Snowtex Outer Wear Ltd (Extension)

12 January 2025

2. Observations:

Observation-5: Trolley impact on columns surface. [Building-10 (Unit-2)]

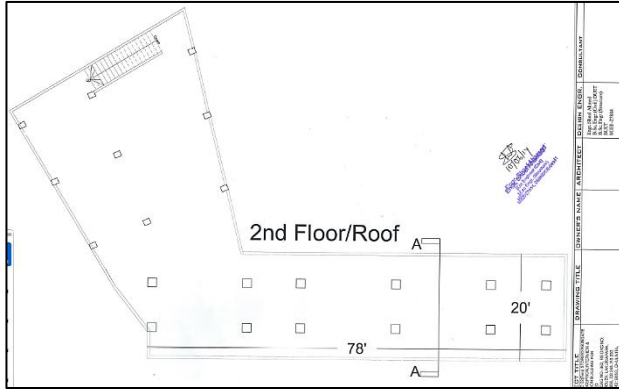
Description: The cover of floor columns was damaged due to trolley impact. The building engineer is required to provide column/wall guard to protect the trolley impact.

6.	Trolley impact on columns surface (Unit-2).	The building engineer is required to provide column/wall guard to protect the trolley impact.	within 6 weeks

Observation-12: Lack of connection detail in the as-built drawings for Building-8 (Compressor Shed).

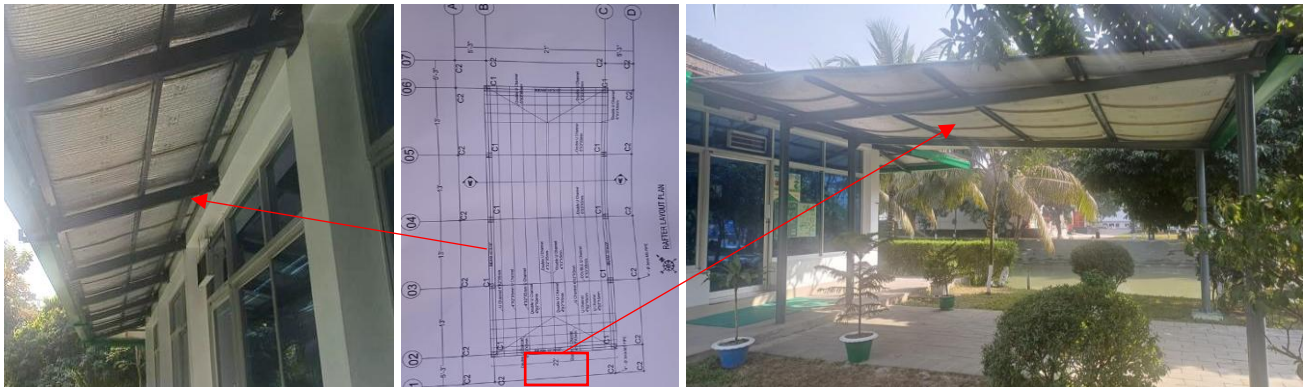
Description: The connection between frames and purlins was not shown in the drawing. The building engineer is required to survey the structure and update the accurate as-built drawing as per actual site condition.

14.	Lack of connection detail in the as-built drawings for Building-8 (Compressor Shed).	The building engineer is required to survey the structure and update the accurate as-built drawing as per actual site condition.	within 6 weeks
